Appendix A – Stakeholder and Public Involvement Materials

Public Comments Received

EAST-WEST BICYCLE AND PEDESTRIAN FACILITIES PLAN

Figure 2. Proposed Struble Connector trail segments in eastern East Brandywine Township. Segment 5 extends from Rock Raymond Road on the southeast to Hopewell Road on the north.

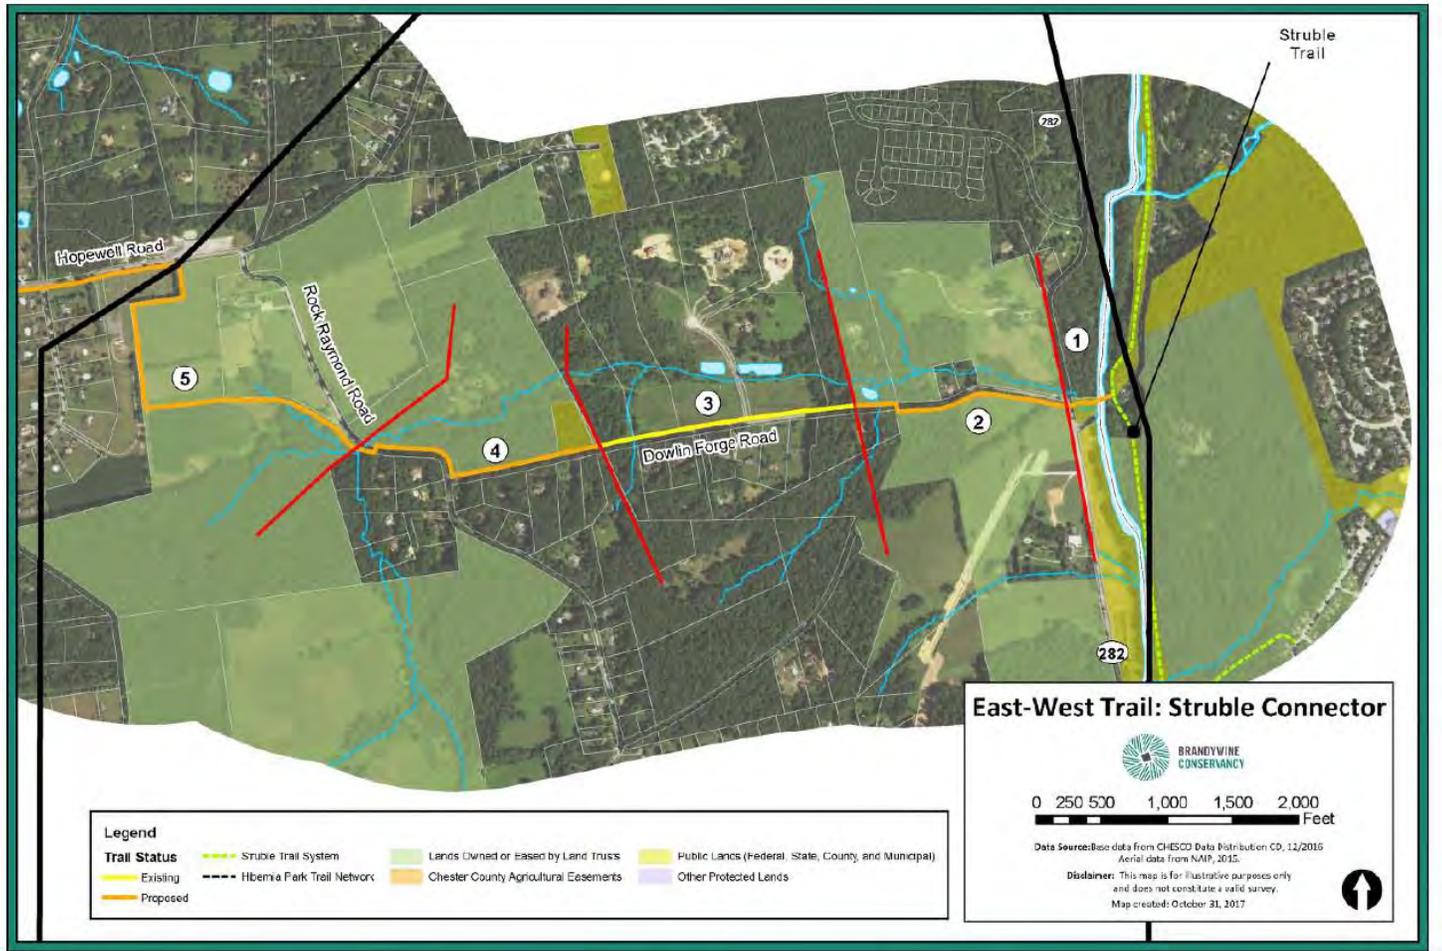
You requested that Schmid & Company staff examine Segment 5 of the proposed Struble Connector route in the vicinity of your property on Rock Raymond Road (Figure 2). Here new trail construction is proposed. You expressed concern because of the apparent conflict this conceptual plan for construction would pose with natural resources such as springs, headwater streams, wetlands, hydric soils, floodways, and riparian corridors of which trail planners appear to be unaware (Figure 3). The current plan for Segment 5 appears to raise major conflicts both with the Article IV Natural Resource Protection Standards of the East Brandywine Township Zoning Ordinance [Township Code 399-12 ff] and with various State and federal requirements. These conflicts seem avoidable and unnecessary as well as imposing excessive monetary costs on the trail project, as detailed below.

As currently proposed, Segment 5 would run for about 200 feet alongside the west shoulder of Rock Raymond Road north of its culvert over a High Quality tributary stream. Then it would head first northwest about 500 feet and then west about 700 feet just to the south of your property line (Figure 4). From there the trail would continue west about 1,000 feet, crossing and then passing alongside a minor tributary stream just to the north of a large cornfield, and then north to Hopewell Road, passing between a cemetery and a fenced open field.

The proposed alignment of Segment 5 intersects several hundred feet of the forested riparian wetlands (Figure 5) and entails several stream crossings. State, federal, and Township applications must be filed and permits approved before any trail construction here can lawfully proceed [East Brandywine Township Code 350-50.C.(2)(g)]. Those applications must include not only full documentation of proposed wetland delineations, but also compliance with bog turtle screening requirements and searches for any animals and plants of special

Figure 3. Excerpt from surface waters (Map 6) of the 2009 East Brandywine Township Comprehensive Plan. Segment 5 of the proposed Struble Connector has been added in orange (at arrow).

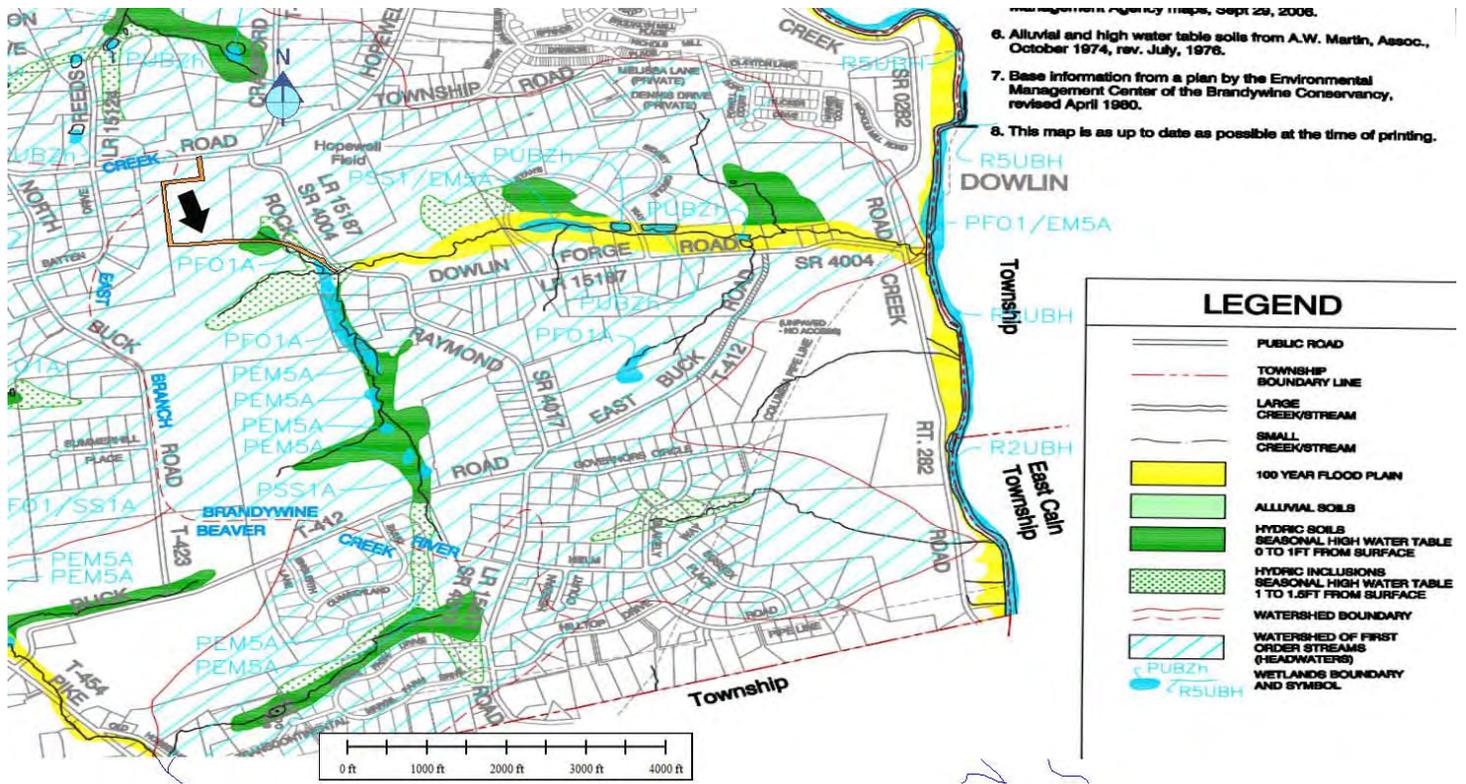
Map 6 (surface waters) in East Brandywine Township's 2009 Comprehensive Plan clearly identifies the resource complex just west of Rock Raymond Road intersected by the currently proposed alignment of Segment 5 (Figure 3). That complex is the source of the potential environmental impacts and regulatory difficulty under discussion herein. Much of this land, if examined closely, would constitute a Water Hazard Soils District as defined in the East Brandywine Township Code [at 399-15.A.(2)]. The 1963 Chester and Delaware Counties soil survey Map Sheet 26 clearly shows hydric Worsham and Weehadkee Series soils in this vicinity; those series labels now have been replaced by other hydric series names including Cokesbury, Holly, Fluvaquents, Andover, and Towhee in the online county soil survey mapping at this location. Prior to detailed engineering for any trail construction here, there must be careful delineation and mapping of all wetlands, streams, and other water resources including springs and hydric soils in this area. Locally these resources are found where groundwater emerges to the surface along the zone of geological contact that runs approximately east-west between the Chickies Quartzite that underlies most of your property and the Granodiorite bedrock that is much more extensive to the south.
